**OEM Product Support Bulletin**

**No. 37**

**SUBJECT:** PENDANT CABLES

**Machine Model (s):** American 825, 830, 840, 850 & 855-DE Series

Figure 1: Pendant Cable with Clipped Ends  
(Old Style)

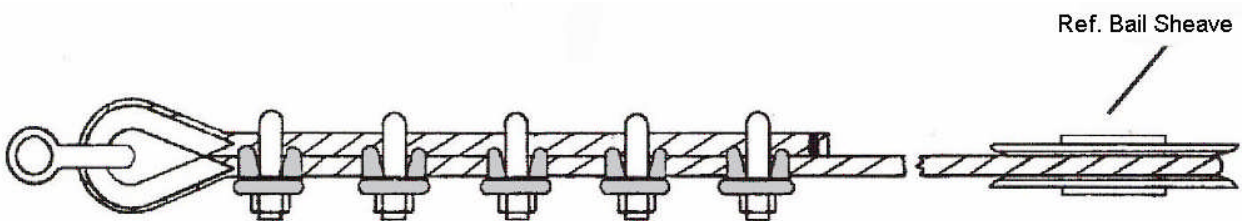
**Summary:** Replacement of the original Clipped Type Pendant Cables to Swaged End Type Fittings on the Pendant Cables

- Increased Strength
- Improved Fatigue and Shock Resistance
- Less Maintenance
- Easier to Install
- Certified to "OEM" Specifications
